Plan Commission

Tuesday, May 28, 2019

SUBJECT: Staff recommendation and possible action regarding a Site Plan for a new playground, two softball diamonds with dugouts and concessions area, electrical conduit, and additional parking for the Westwood Elementary School and West De Pere Middle School at 1155 Westwood Drive (Parcel WD-D0022 & WD-D0220). Submitted by Dan Peplinski, Point of Beginning INC, authorized representative for School District of West De Pere, property owner.

Sheet Number:
C101R

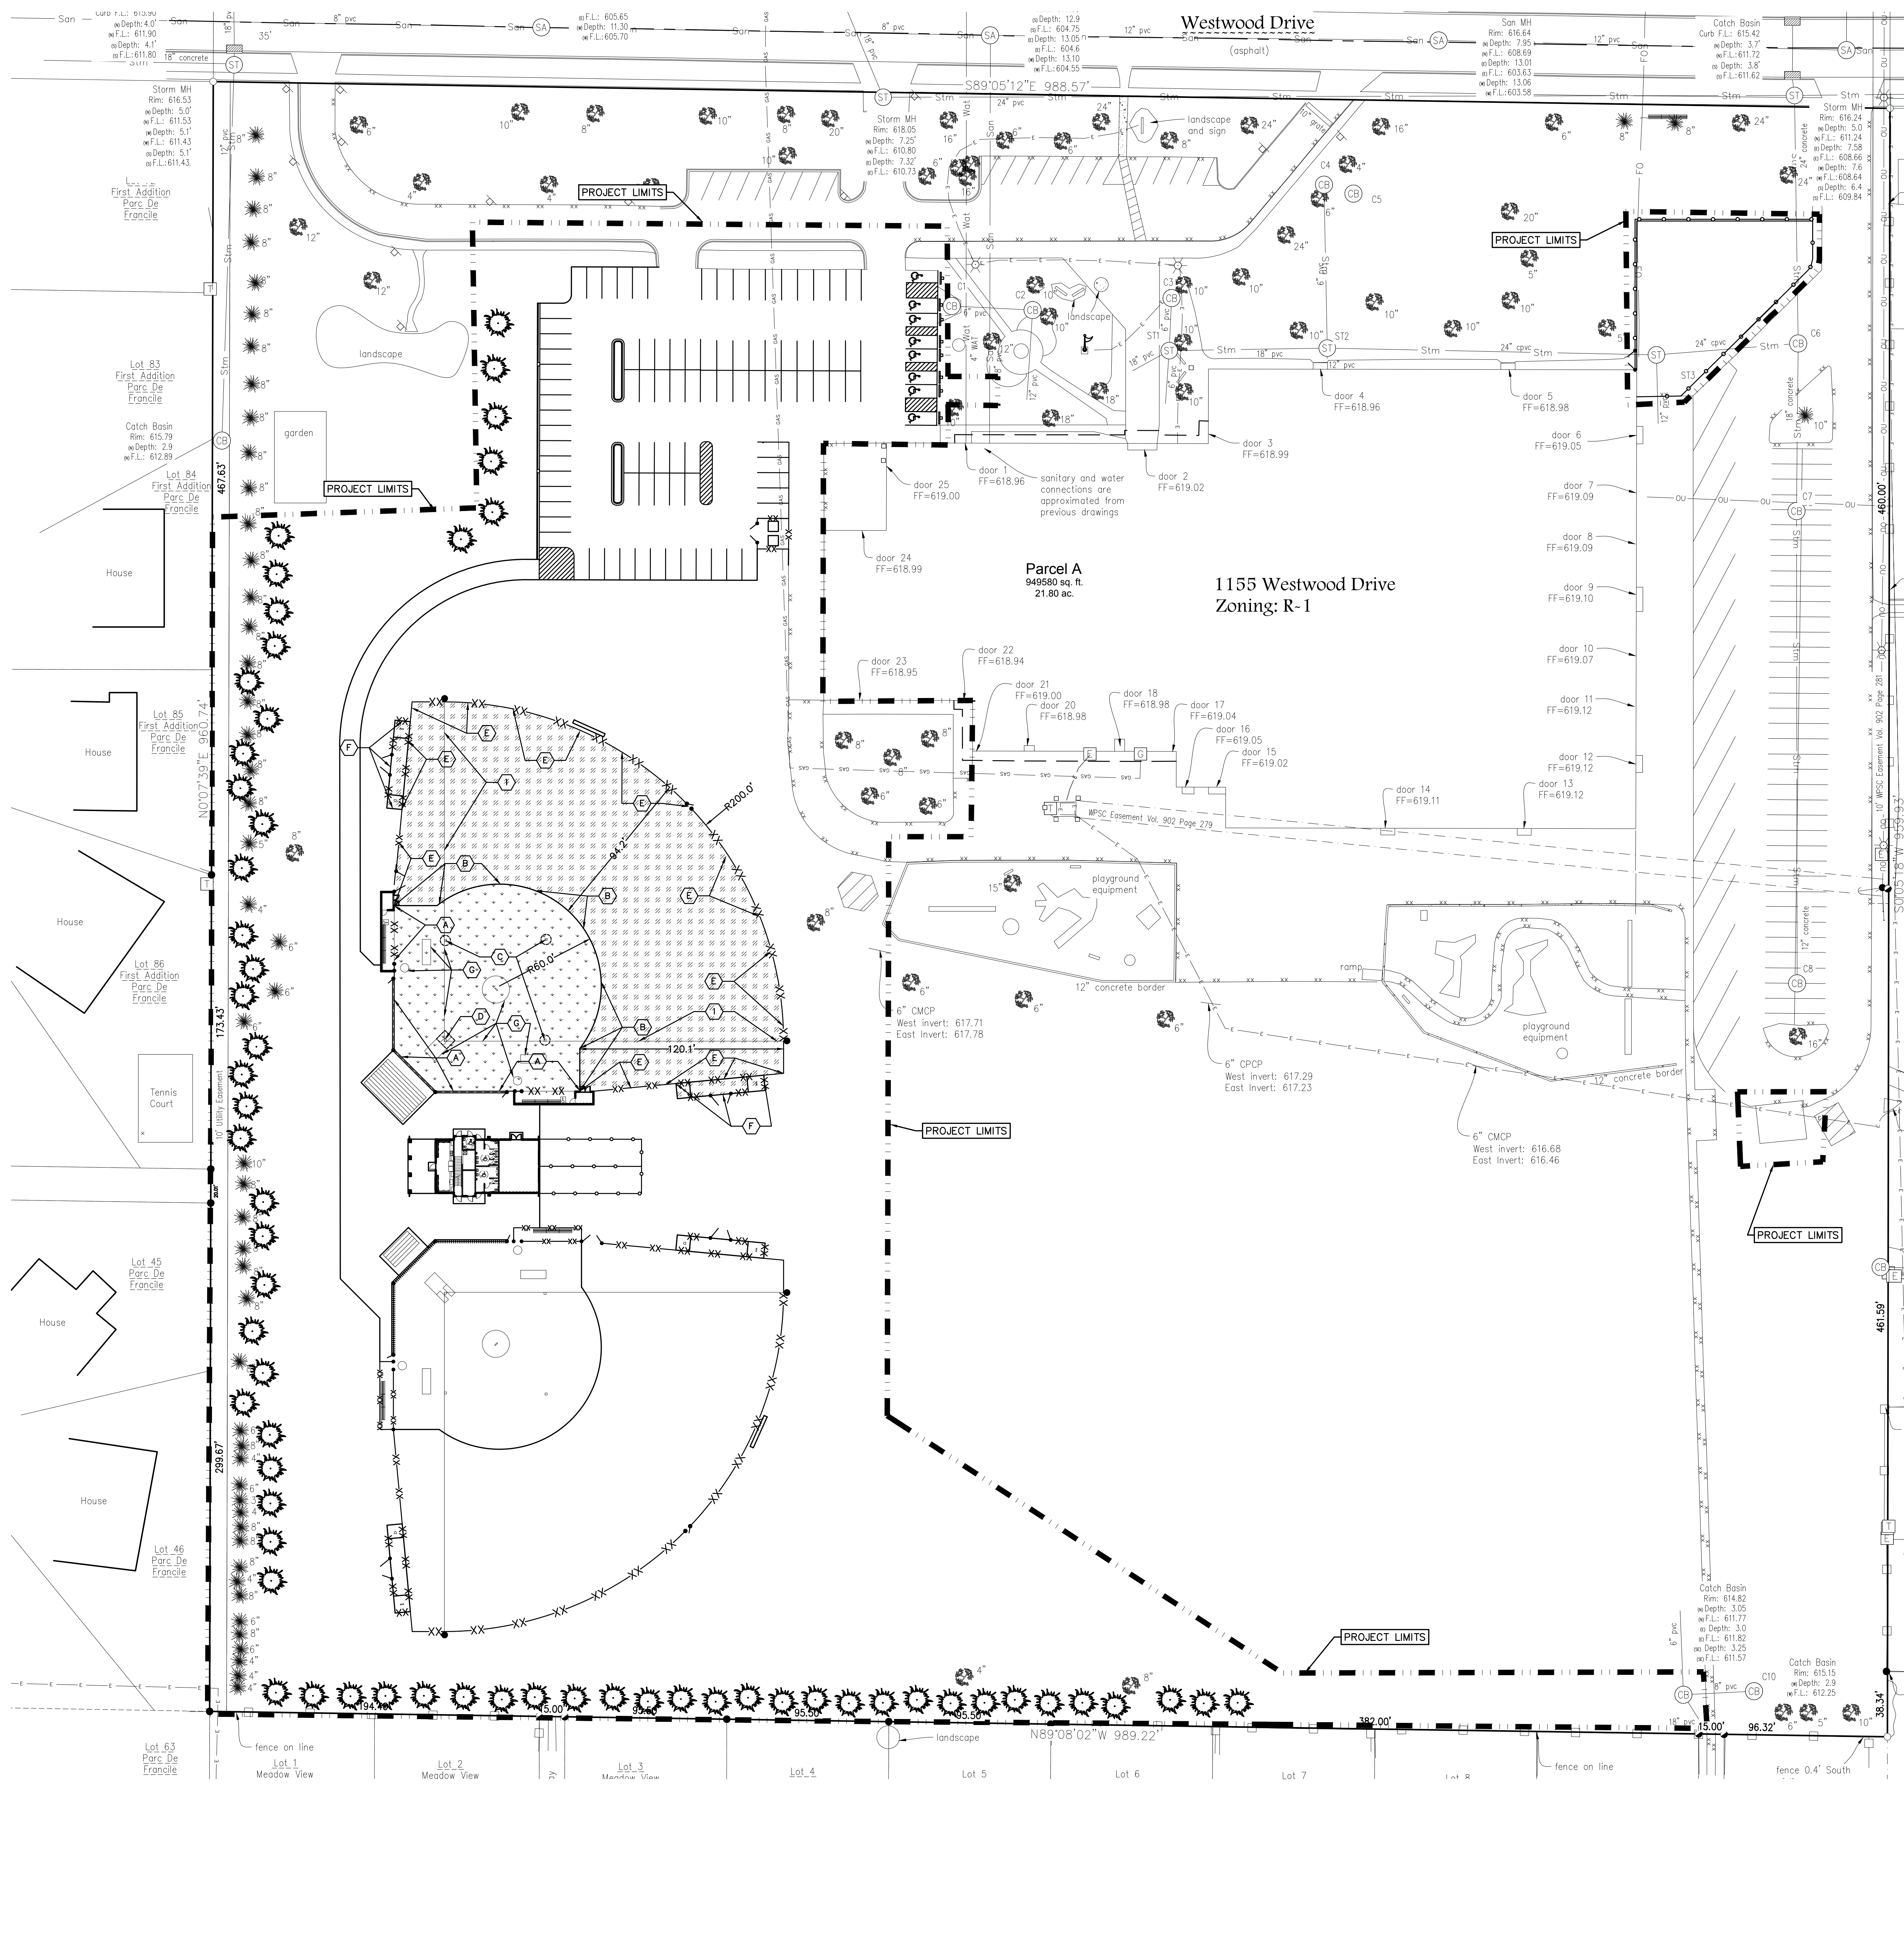
3. Sheet C101 - Striping shall be 4". Provide a chart for total parking stall and confirmation that ADA requirements are being met.
4. Sheet C102 - Bio-retention is spelled incorrectly.

- Owner information/ address provided on sheet C101R.
- Water to be metered inside of new concessions building.
- Striping stated to be 4" wide, see sheet C101R.
- Total parking count with ADA stalls stated on sheet C101R.
- Bio-retention spelled correctly on sheet C102.
- Curbing is added along west edge of proposed parking lot to ensure storm water is collected within the parking lot.
- Conduit stated to be installed per sheet C102. NO stadium lighting at this time.
- SWMP is attached/ provided per city requirements.
- Stockpile locations are stated on erosion control plan sheet C103R with protected measures.
- SWMP is provided to state TSS removals.
- Storm water maintenance agreement has been forwarded to school for signing.
- Additional landscaping plantings have been provided on sheet C102.
- ADA route provided on sheet C102 for site access.
